HISTORIC AND DESIGN REVIEW COMMISSION July 21, 2021

HDRC CASE NO: 2021-328 ADDRESS: 621 HAYS ST

TYPE OF WORK: Fenestration modifications, door removal, repair and maintenance

EXISTING WEST ELEVATION sc.: 1/4"

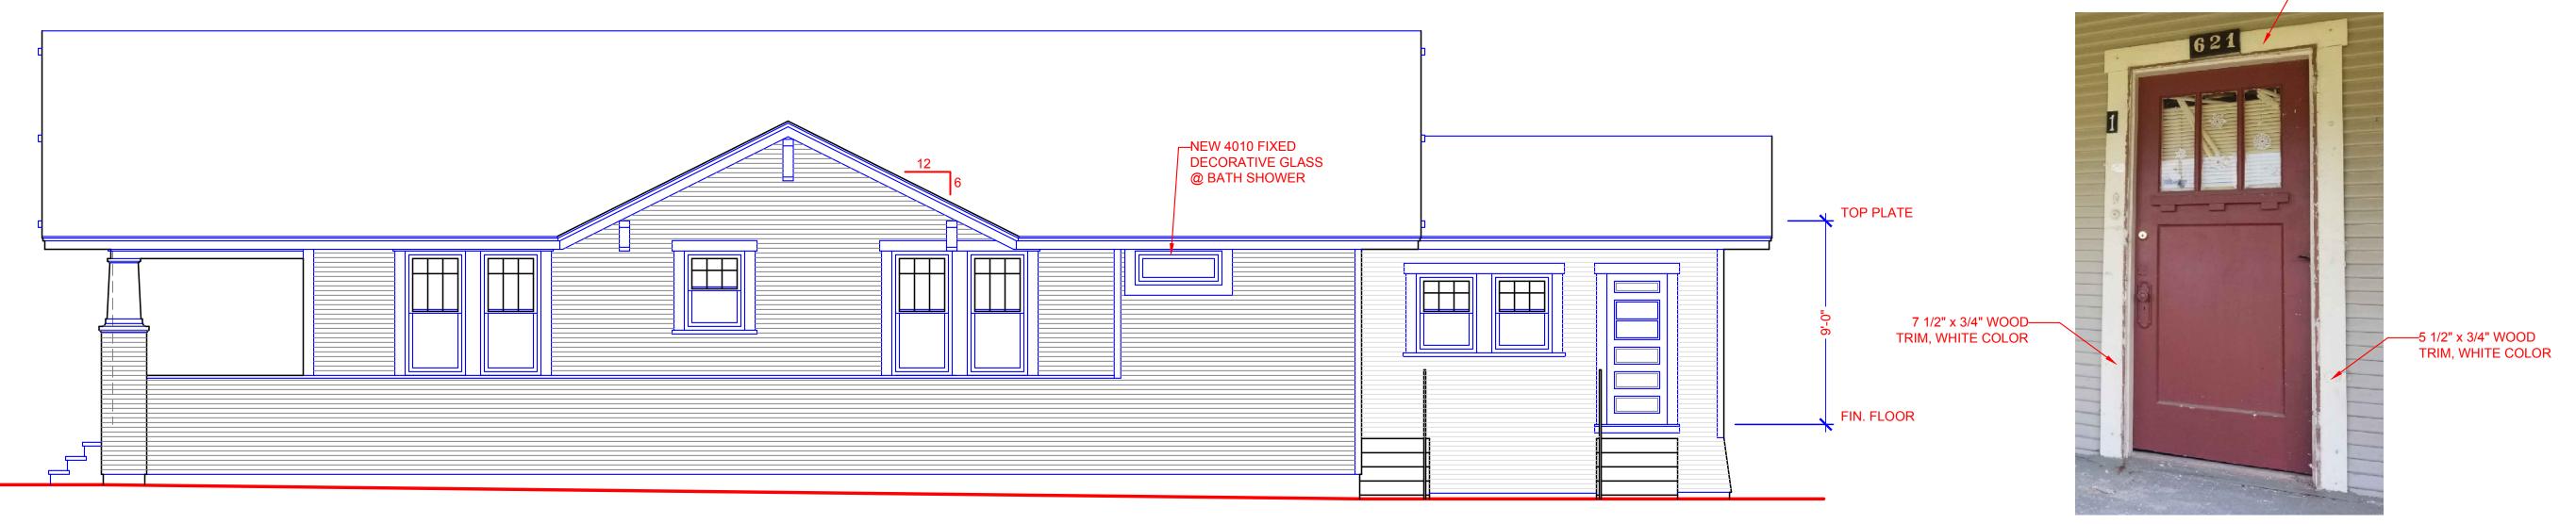
- d. FENESTRATION MODIFICATIONS (West Façade) The applicant has proposed to perform fenestration modifications on the west façade, including the removal of an original window and the relocation of two existing windows. Per the Guidelines for Exterior Maintenance and Alterations, 6.A.i., historic window and door openings should be preserved. Staff finds the proposed fenestration modifications to be inappropriate and inconsistent with the Guidelines.

- 1. Staff recommends approval of item #1, siding repair and painting with the stipulation that the existing brick chimney remain unpainted.
- 2. Staff does not recommend approval of item #2, the removal of the westernmost front door based on finding c. Staff recommends that the existing door opening remain in place. The existing, non-original door may be replaced with a door that wood and matches the profile of the existing, Craftsman door.
- 3. Staff does not recommend approval of item #3, fenestration modifications to the west façade based on finding d. Staff recommends that all historic window openings remain as they currently exist.

PROPOSED EAST ELEVATION sc.: 1/4"

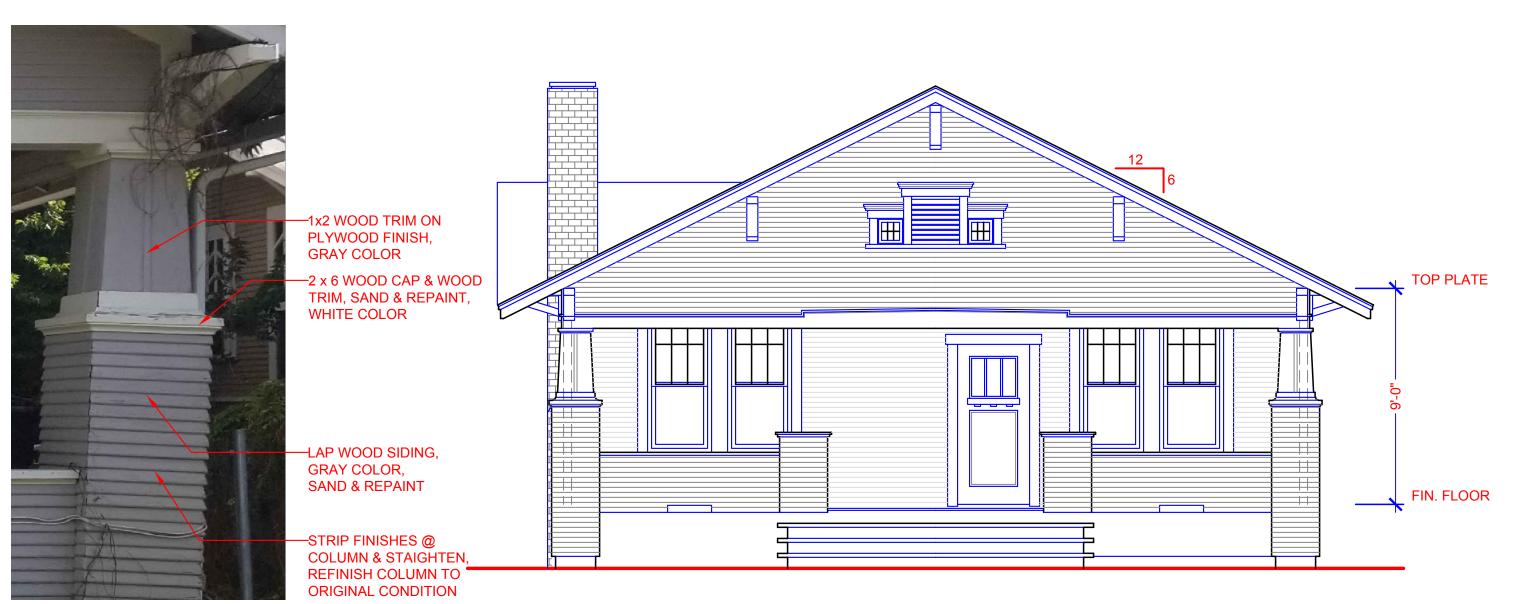
- e. FENESTRATION MODIFICATIONS (East Façade) The applicant has proposed to perform fenestration modifications on the east façade, including the removal of two, historic windows, and the installation of a contemporarily sized window. Per the Guidelines for Exterior Maintenance and Alterations, 6.A.i., historic window and door openings should be preserved. Staff finds the proposed fenestration modifications to be inappropriate and inconsistent with the Guidelines. Additionally, staff finds the installation of a white, vinyl window within the historic structure's footprint to be inappropriate and inconsistent with the Guidelines.

4.	Staff does not recommend approval of item #4, fenestration modifications to the east façade based on finding e. Staff recommends that all historic window openings remain as they currently exist and that no new window openings be created.
